**1.IEEE P802.11**

**Proposed text for section 11**

**Based on responses to Draft D1 Letter Ballot processed  
at March 1995 Meeting.**

**Abstract:** This paper presents the changes to section 11 in the Draft Standard P802.11/D1 as a result of the Response to Draft D1 Letter Ballot processed at the March 1995 Meeting as shown in the companion document P802.11-95/72

Figure 11-2: PLCP Frame Format

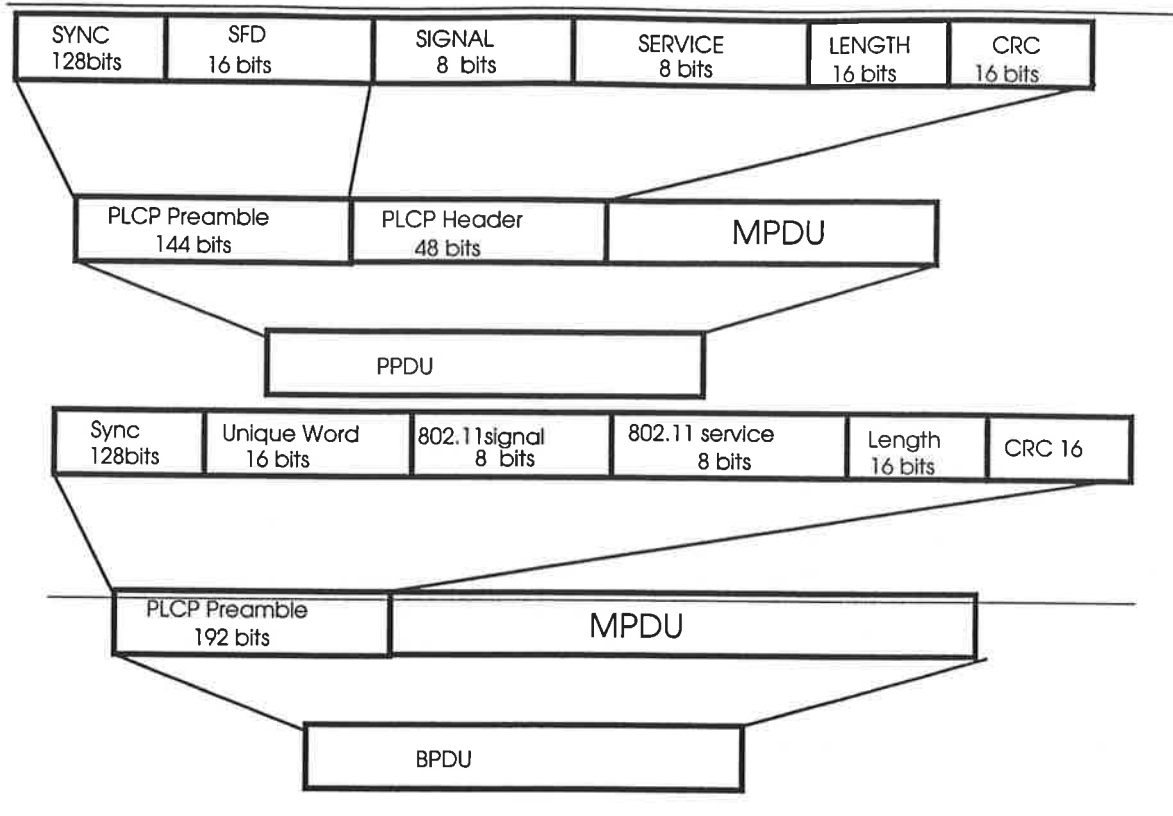
Figure 11-2 shows the format for the ~~PPDUBPDU~~ including the PLCP preamble, ~~the PLCP header~~ and the MPDU. The PLCP preamble contains the following fields: synchronization (SYNC) ~~and, unique word, Start Frame Delimiter (SFD)~~. ~~The PLCP header contains the following fields:~~ 802.11 signaling (SIGNAL), 802.11 service (SERVICE), length (LENGTH), CRC-16. Each of these fields ~~shall~~ will be described in detail in section 11.2.3.
